Accessibility Survey

City of Downey Tweedy Lane - Brookpark Road to Telegraph Road

Date of Inspection
6/22/2017

Prepared By
Disability Access Consultants
(800) 743-7067

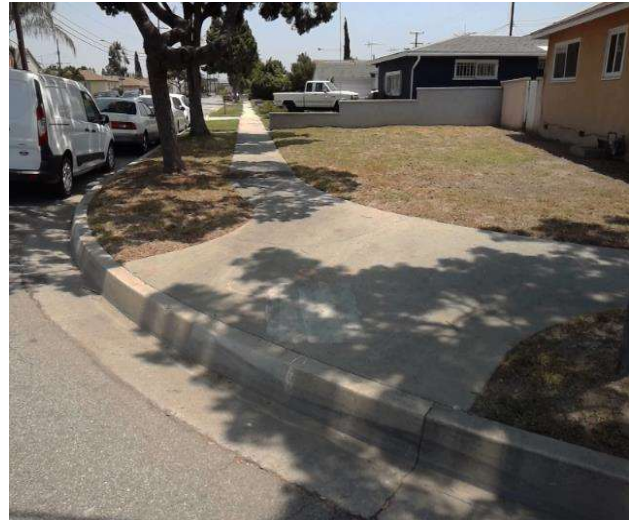
There is a curb on the designated path of travel.

On-Site Finding Not Compliant

Provide a compliant curb ramp.

Change in Level South of Suva Street @ 33.957695275490, -118.129126578569

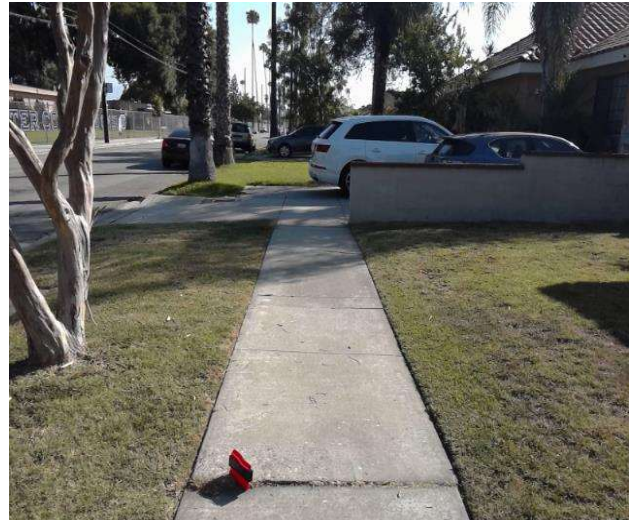
There is a change in elevation greater than recommended value.

On-Site Finding 0.50 inches

Ensure that the change in elevation is within the recommended value.

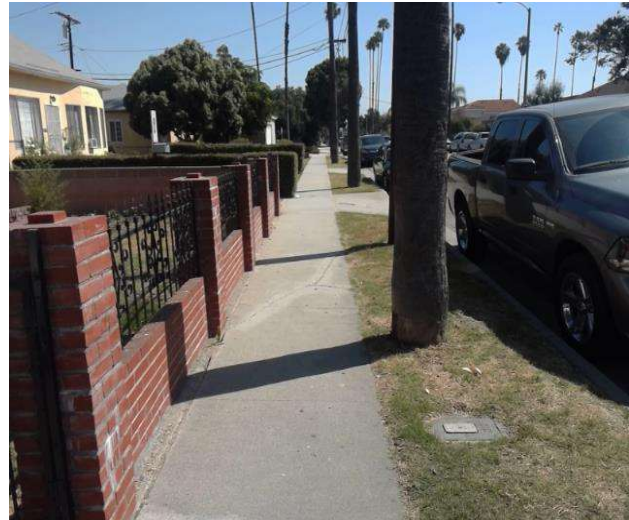
Sidewalk cross slope is not compliant.

On-Site Finding 4.20 percent for 31.00 feet

Repave the sidewalk surface with the recommended cross slope.

Change in Level South of Coolgrove Drive @ 33.963274787806, -118.125300407410

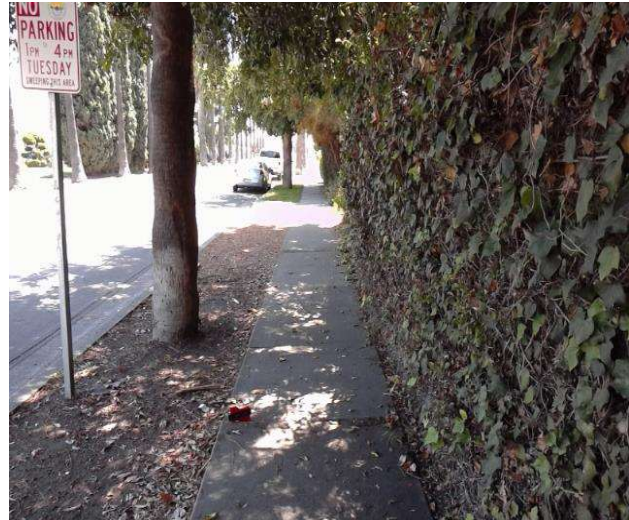
There is a change in elevation greater than recommended value.

On-Site Finding 1.50 inches

Ensure that the change in elevation is within the recommended value.

Change in Level South of Coolgrove Drive @ 33.963203600161, -118.125354051590

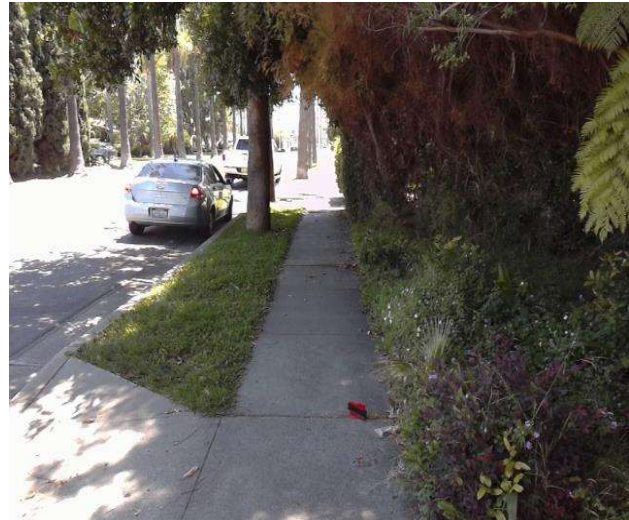
There is a change in elevation greater than recommended value.

On-Site Finding 0.75 inches

Ensure that the change in elevation is within the recommended value.

Change in Level South of Coolgrove Drive @ 33.963337076946, -118.125257492065

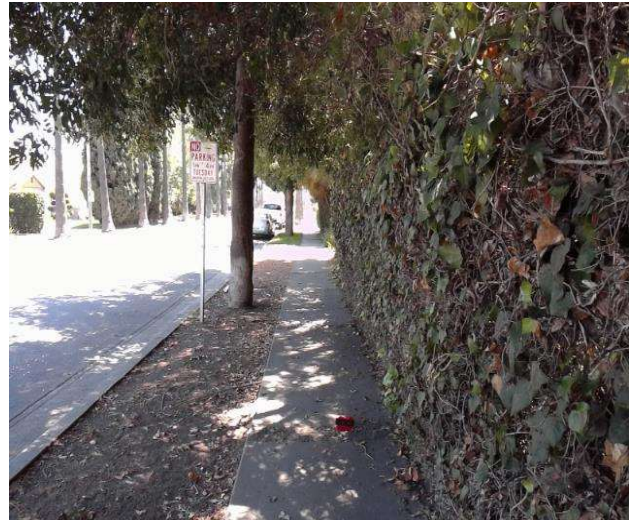
There is a change in elevation greater than recommended value.

On-Site Finding 0.62 inches

Ensure that the change in elevation is within the recommended value.

Change in Level South of Coolgrove Drive @ 33.963426061354, -118.125187754631

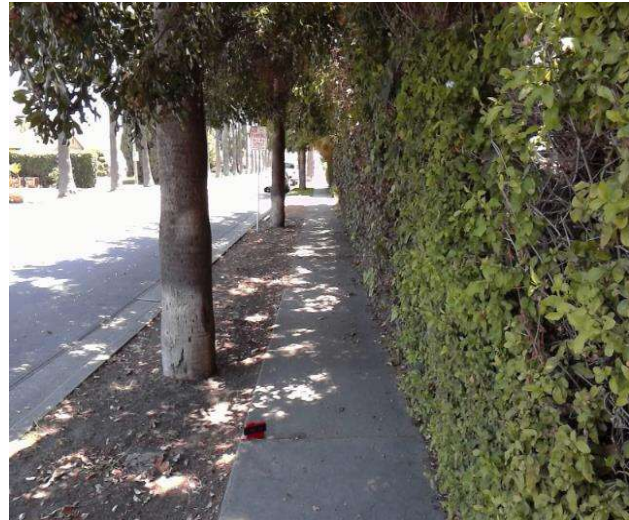
There is a change in elevation greater than recommended value.

On-Site Finding 0.50 inches

Ensure that the change in elevation is within the recommended value.

Change in Level South of Coolgrove Drive @ 33.963893227965, -118.124860525131

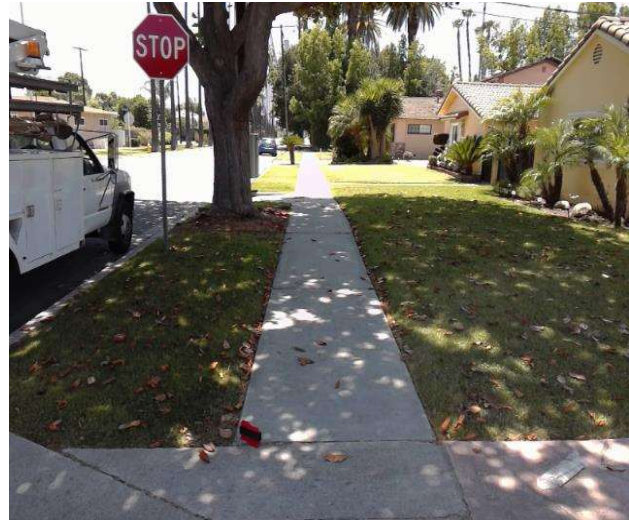
There is a change in elevation greater than recommended value.

On-Site Finding 0.50 inches

Ensure that the change in elevation is within the recommended value.

Change in Level South of Coolgrove Drive @ 33.963590682262, -118.125085830688

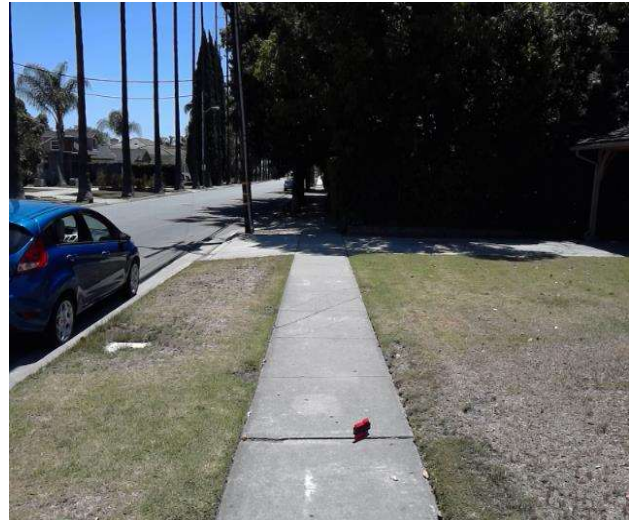
There is a change in elevation greater than recommended value.

On-Site Finding 0.37 inches

Ensure that the change in elevation is within the recommended value.

Change in Level South of Raviller Drive @ 33.961546245961, -118.126571774483

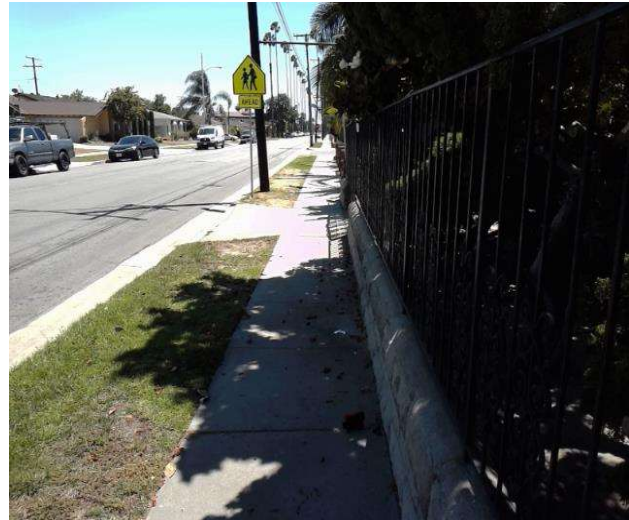
There is a change in elevation greater than recommended value.

On-Site Finding 0.37 inches

Ensure that the change in elevation is within the recommended value.

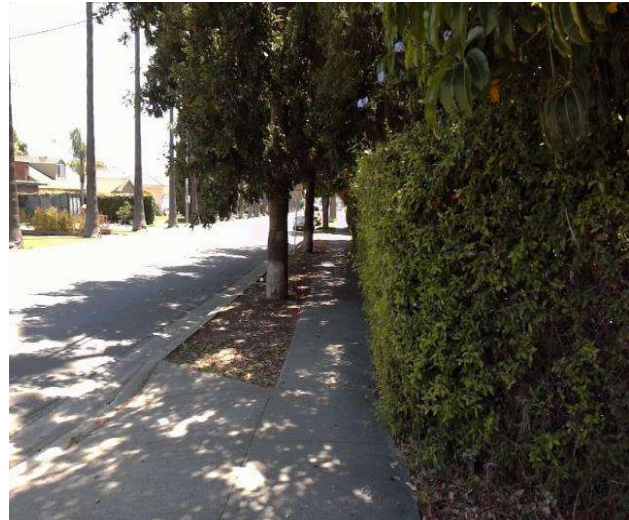
Sidewalk width at the obstruction is not compliant.

On-Site Finding 42.00 inches

Sidewalk width at the obstruction shall have the recommended value.
